HILLCREST COMMONS
FINAL ENVIRONMENTAL IMPACT STATEMENT

NYS Route 52
Towns of Carmel and Kent, New York

HILLCREST COMMONS
Final Environmental Impact Statement
Towns of Carmel and Kent, Putnam County, New York

Addendum

Figure 14-1: Northern Access Alternative
 Road Access Plan
 Hillcrest Commons
 Towns of Carmel and Kent
 Putnam County, New York
 Source: Insite Engineering, Surveying &
 Landscape Architecture, P.C.
 Date: 11/05

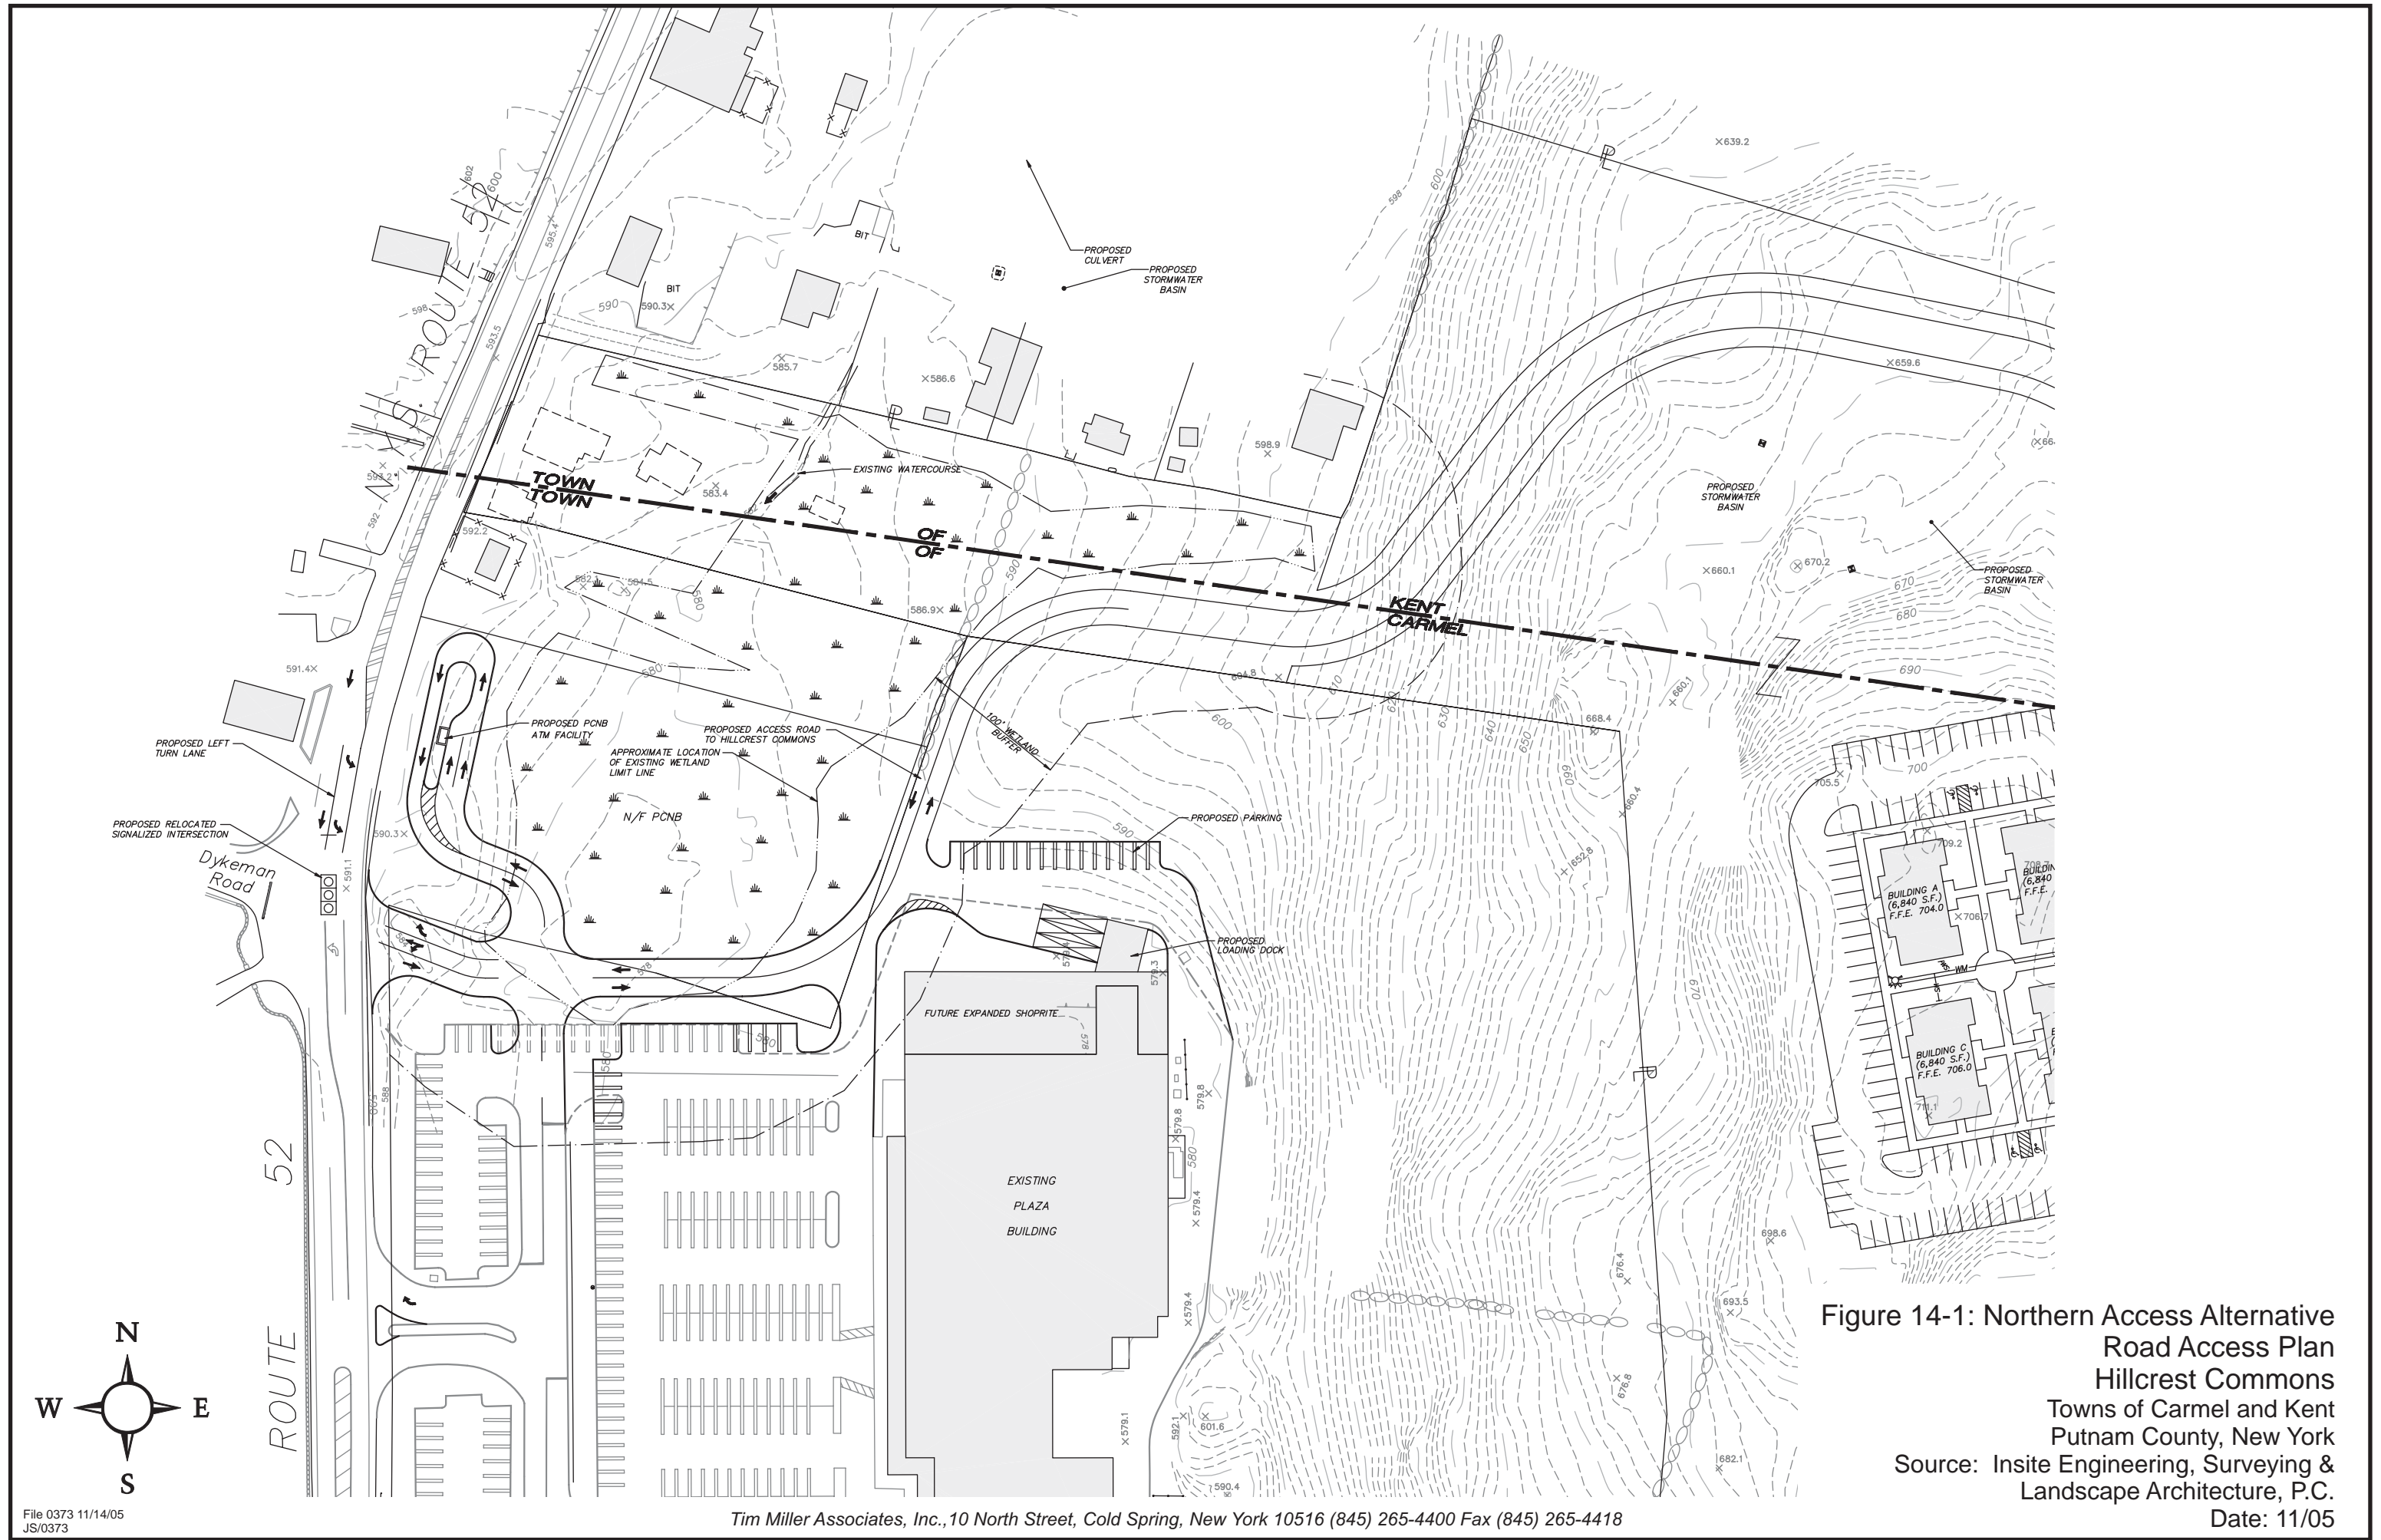
Comment 14-5 (Letter #1, Letter from NYC DEP, August 5, 2005): Alternative 4 in the DEIS mentions potential impacts on wetlands and wetland buffers, but fails to quantify those potential

A) This access alternative is shown on Figure 14-1 and requires land that is not owned or under the control of the Applicant. Nonetheless, it is reviewed herein in the event that it can be implemented at some future time.

Based upon engineering review of required cuts and fills, the northern access alternative would require approximately the same amount of wetland filling (approximately 0.4 acres) as the proposed site plan (see Figure 1-2). This filling would occur on the southern edge of Wetland A, on a parcel now owned by a third party. According to the Applicant, this alternative would have less wetland impacts, since the edges of Wetland A would be disturbed, instead of bisecting the northern portion of the wetland, as would occur for the proposed plan.

This alternative location for the project access would be at the northern edge of the ShopRite Plaza parking lot, directly opposite Dykeman Road. A diagram of the access is provided in Figure 14-1. In terms of natural resource impacts, including site disturbance and wetland impacts, the Applicant notes that this alternative has the least impacts, and would provide traffic benefits, as described below.

Based upon engineering review of required cuts and fills, the northern access alternative would require approximately the same amount of wetland filling (approximately 0.4 acres) as the proposed site plan (see Figure 14-1). This filling would occur on the southern edge of Wetland A, on a parcel now owned by a third party. According to the Applicant, this alternative would be preferable in terms of wetland impacts, since the edges of Wetland A would be disturbed, instead of bisecting the northern portion of the wetland, as would occur for the proposed plan.
